SERVICE BULLETIN No: BO-23/2016 MDM-1 FOX

DESIGNATION-TYPE/MODEL: MDM-1 FOX

replacement of control stick at front seat

constitutes Alternative Method of Compliance with Airworthiness Directive EASA No 2015-0182-E

Verification of control stick clearance

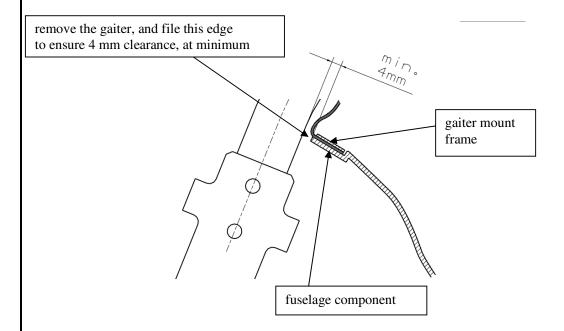
- 1. Replace the installed now at front seat aluminium tube of control stick (conforming to Dwg. No: B2-10.25.01) with steel one (conforming to Dwg. No: B2-10.25.01_rev2) by method described in WORKING INSTRUCTION, referred to under item 5 ENCLOSURES
- After installation, make a verification of clearance between the control stick tube and the rim of fuselage seat pan and gaiter mount frame (procedure cited in the next page).
 Such verification is to be repeated at every annual/ 100-hour inspection of the glider (whichever expires first).
- 3. Record the introduced modification in glider logbook.

With control circuits assembled, check & adjust as necessary the available deflection of control surfaces – see item 2.2 CONTROL SYSTEMS ... in Technical Service Manual. Measure the clearance between tube of control stick at front seat and the rear rim of fuselage cut-out & cover at stick mount, for stick maximum rearward position (ailerons neutral and maximum Left/ Right deflection). For the clearance below 4 mm – file the rear rim of fuselage components to ensure this minimum value.
